VEPCO NOMAD CODE AND MODEL SUPPLEMENTAL INFORMATION.

Docket # 50-280
Control # 8407170305
Date 7/6/84 of Document:
REGULATORY DOCKET FILE

RESPONSE TO QUESTIONS AND COMMENTS ON VEPCO NOMAD CODE AND MODEL (VEP-NFE-1)

FIGURE 1.3

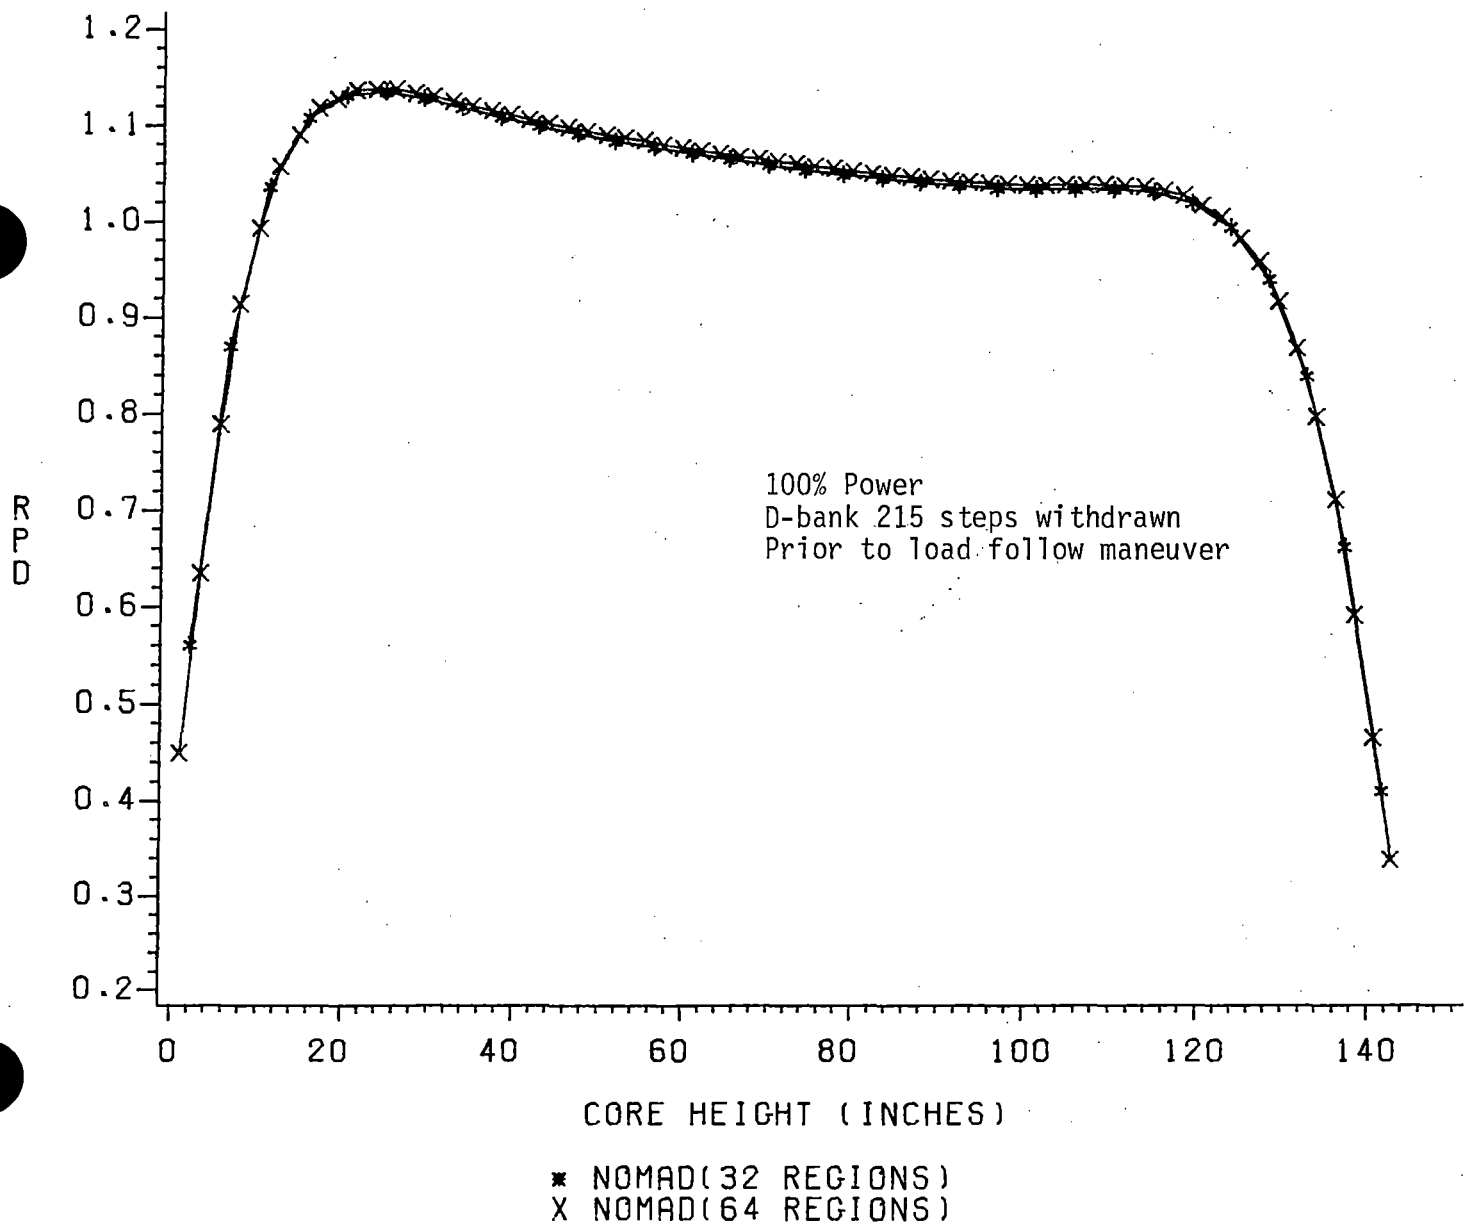
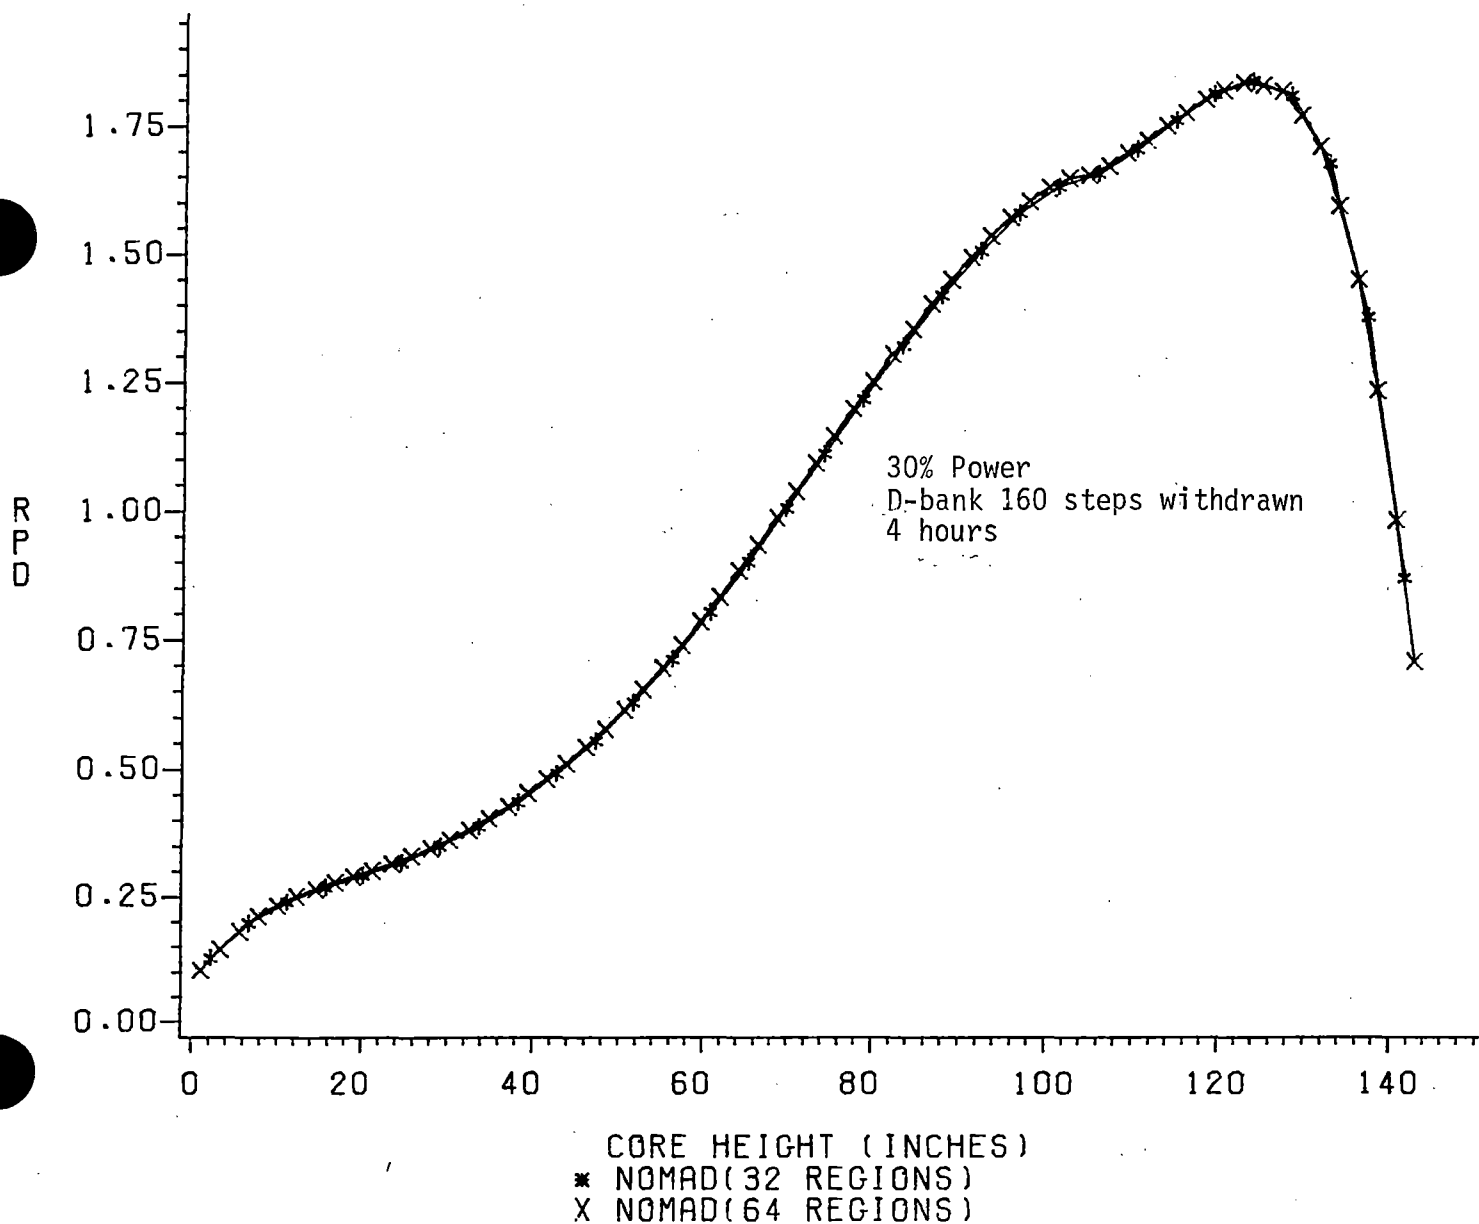
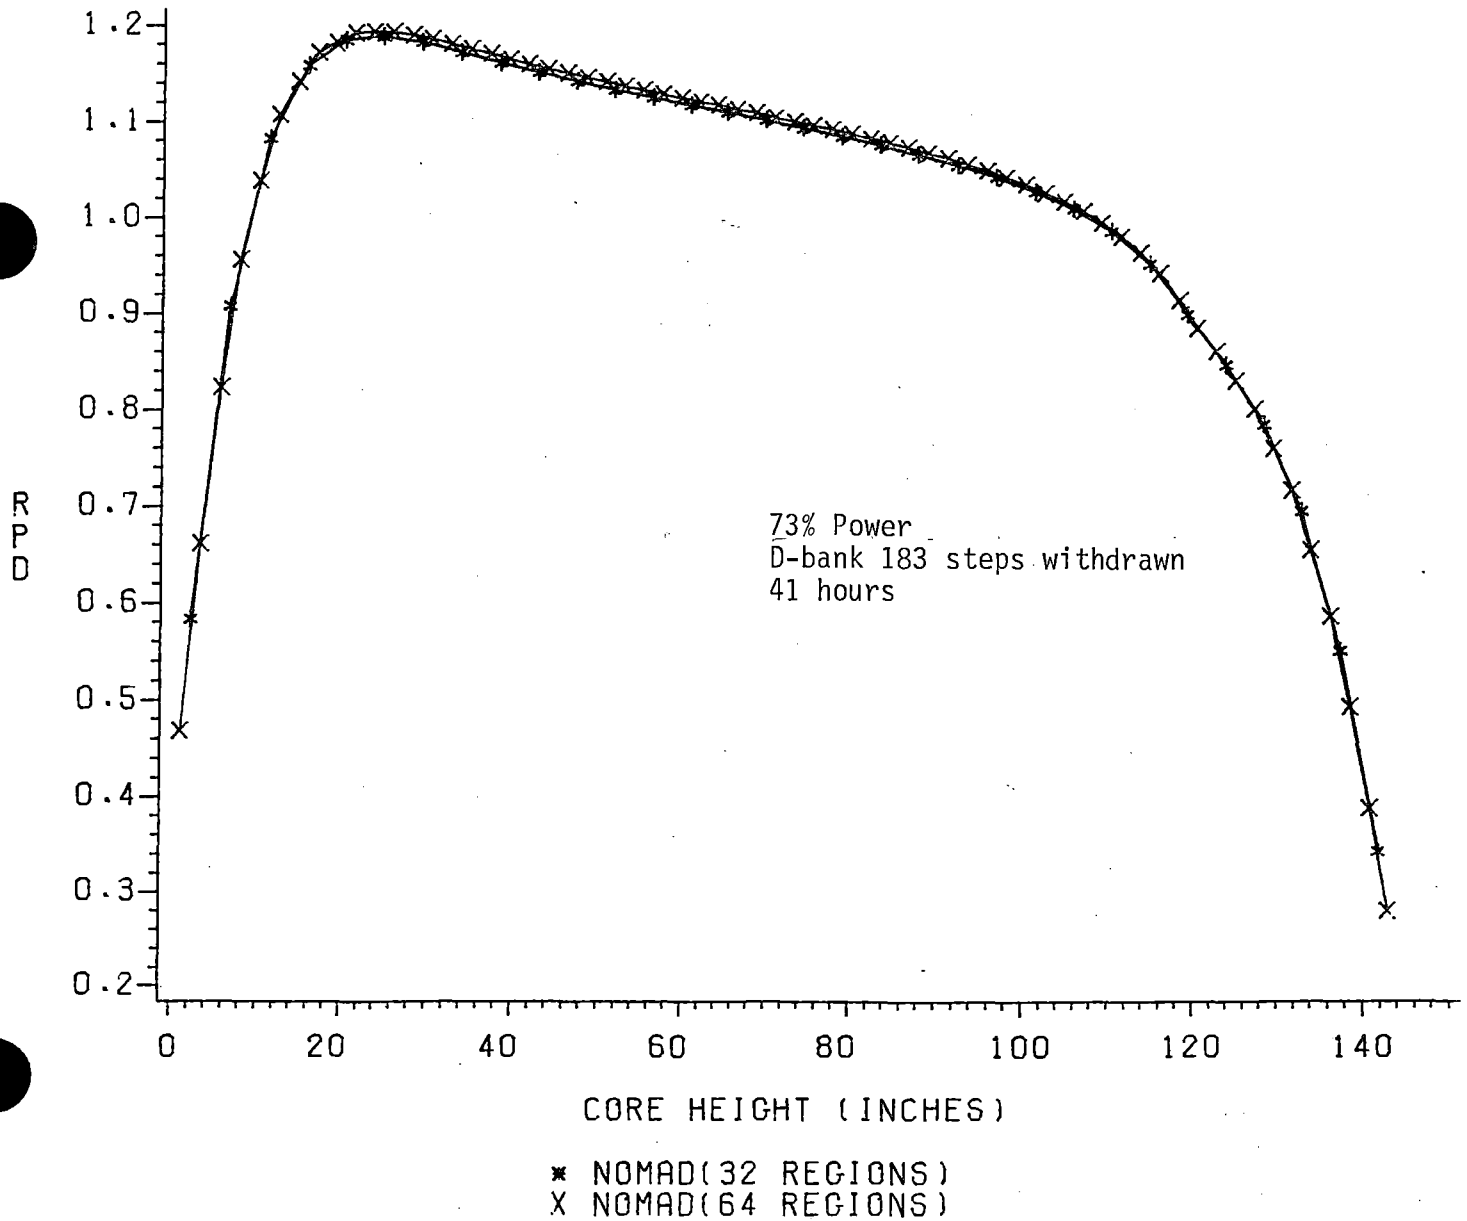
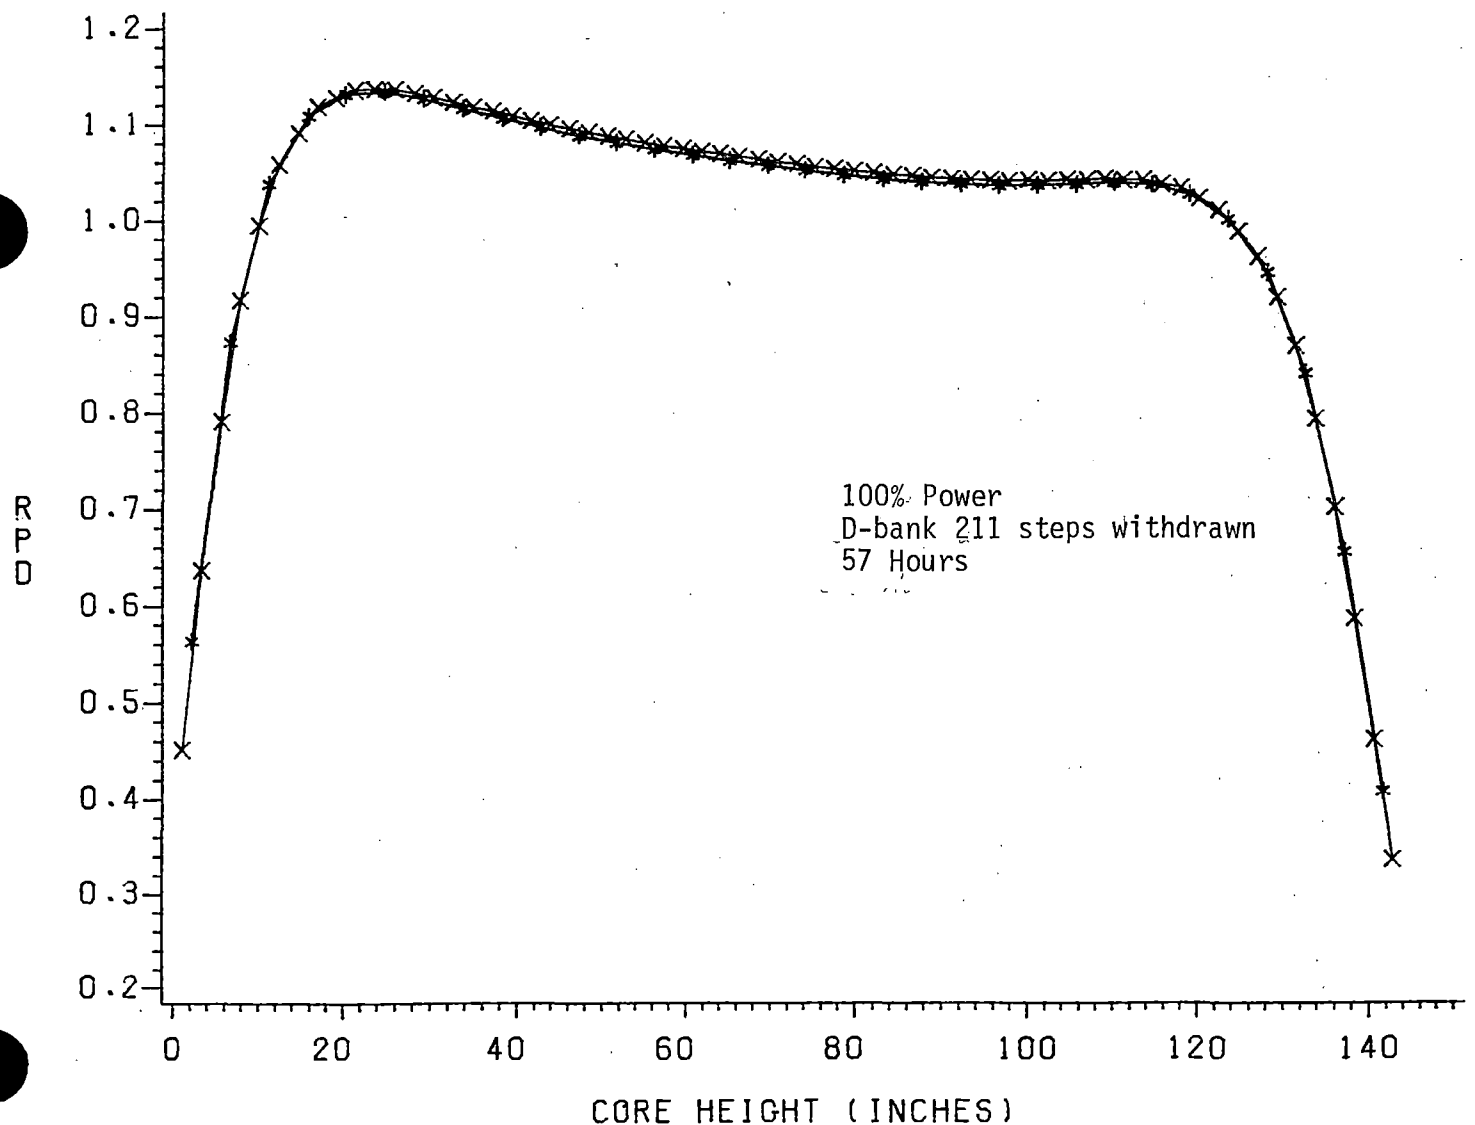
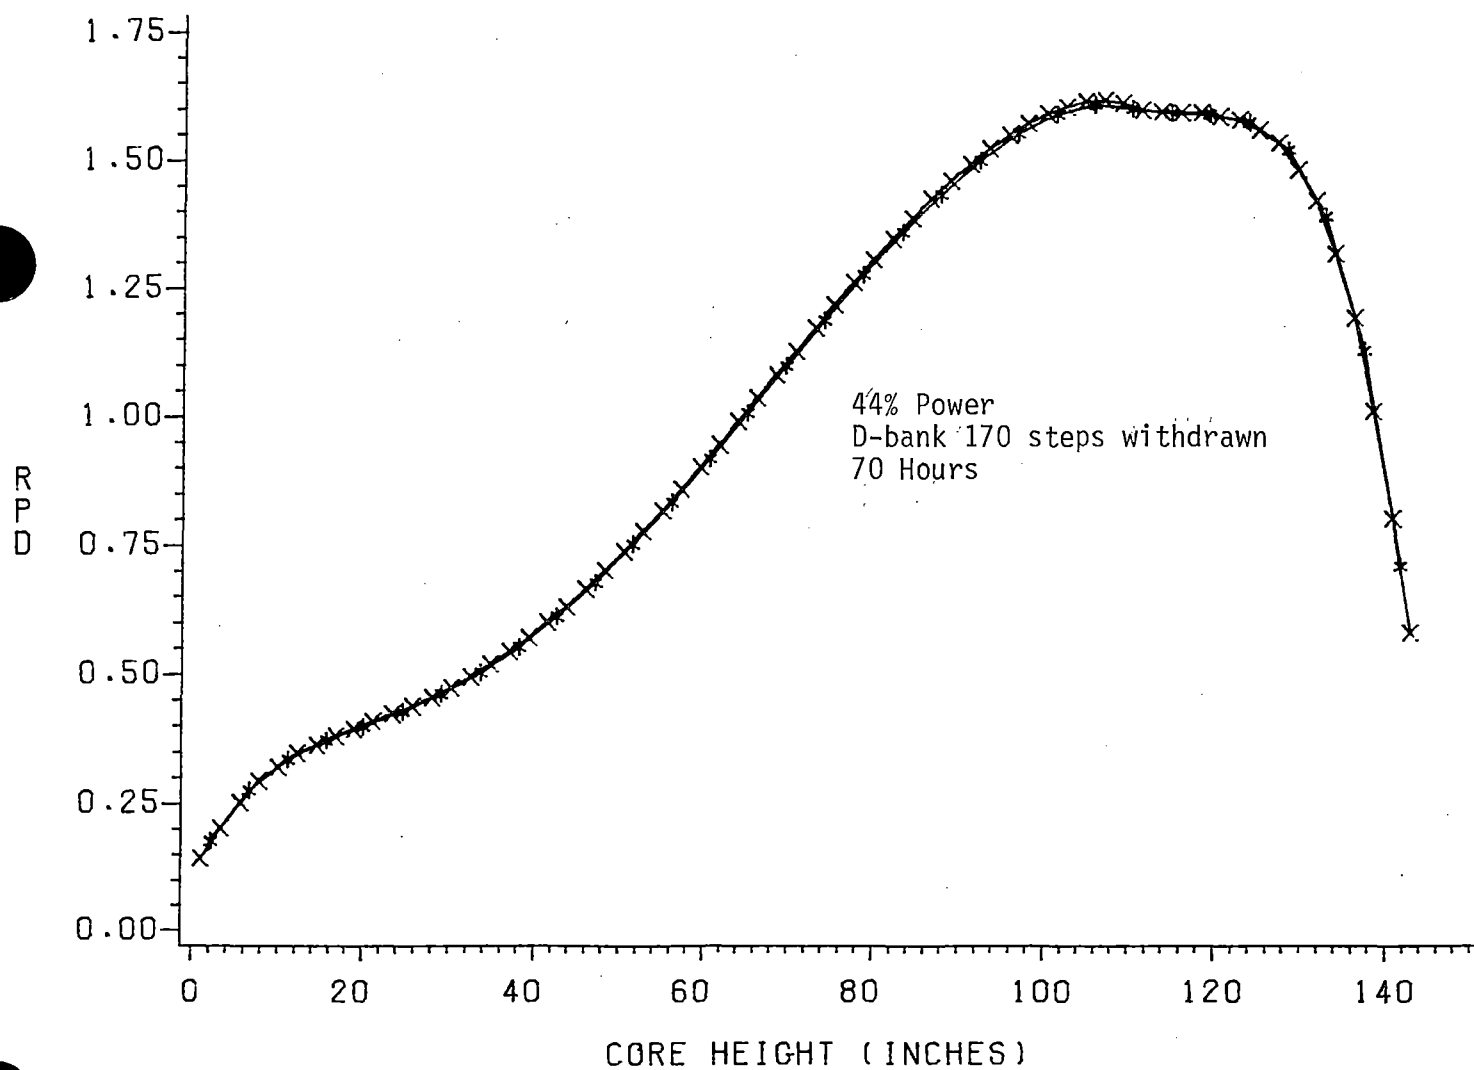
Question 1. The NOMAD model represents the fuel by 32 axial regions.

This implies an axial mesh spacing of more than 11 cm which is large for an explicit 2-group, finite difference code, particularly in light of studies of the dependence of finite difference generated results to mesh spacing.

To demonstrate the accuracy of the 32 axial region model, one of the load follow maneuvers from Section 5.6 (N1C3 Shutdown/Return to Power Case 1) was performed with the 32 axial region model and with a 64 axial region model. Figures 1.1 and 1.2 show virtually identical results for delta-I and critical boron concentration throughout the case. Figures 1.3 through 1.8 show comparisons of axial power distributions calculated at specific

timesteps during the load follow simulation. The 32 region model local power predictions are never more than 0.9% less than the 64 region model results for any of these cases.
